**RE: Williamsburg Landing Nursing and Living Facility  
(Now Woodhaven at Williamsburg)  
Plan No. SP-50-96  
BMP ID Codes: CC 012 (BMP 2 Timber Crib)  
AES Project No. 8162**

Re: Williamsburg Landing (County Plan SP-50-96)  
Nursing & Assisted Living Facility  
Record Drawings and Construction Certification

Project: Williamsburg Landing Nursing & Living Facility (now Woodhaven at Williamsburg)  
Plan No.: SP-50-96  
BMP ID Codes: CC 011 (BMP 1 Dry Pond) & CC 012 (BMP 2 Timber Crib)

NOTES AND DETAILS  
REVISIONS  
NO. DATE DESCRIPTION  
1 6/25/96 REV. PRE. JCC COMMENTS - RHP  
2 7/19/96 COORDINATION/ADDENDUM NO. 4  
3 7/29/96 COORDINATION/ADDENDUM NO. 5  
4 11/21/96 REVISED BID DOCUMENTS

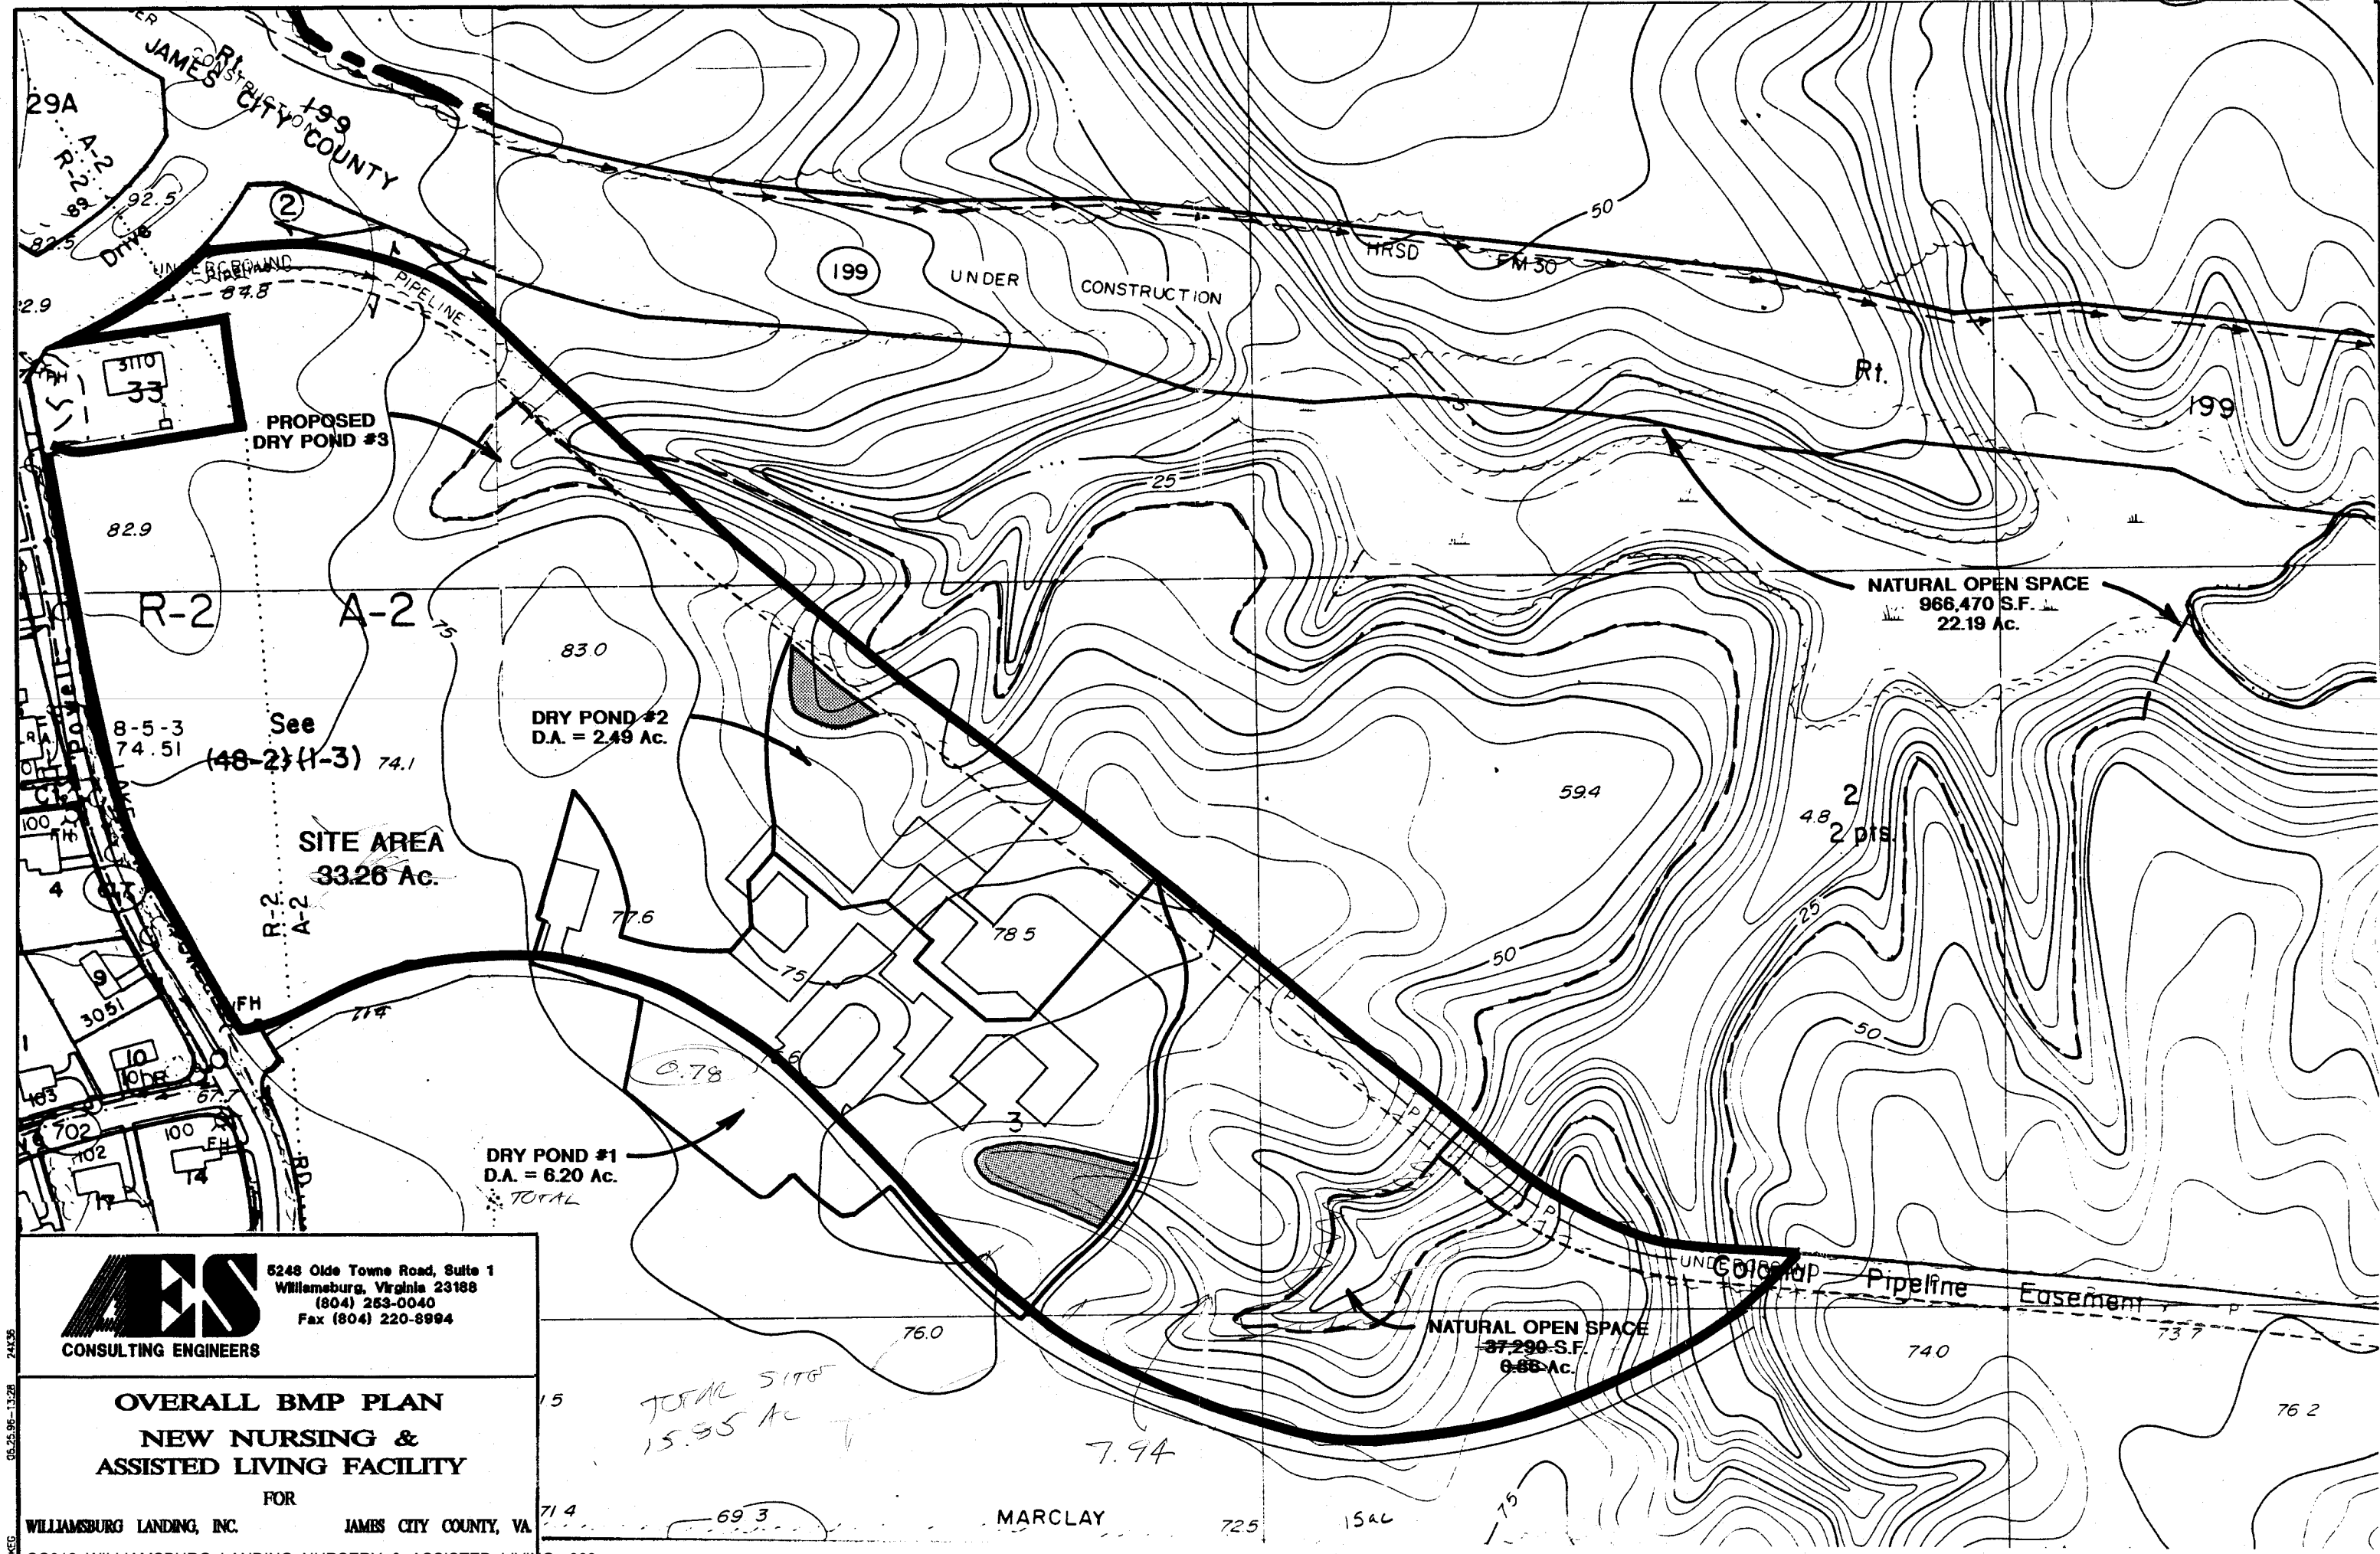
11. Dry Pond # 2. The 3 inch diameter PVC riser needs perforated in accordance with the approved plan. Perforations were only visible on the bottom portion of the riser. Also, perforations that are present in the bottom half of the riser were clogged with organic material and need cleaned.
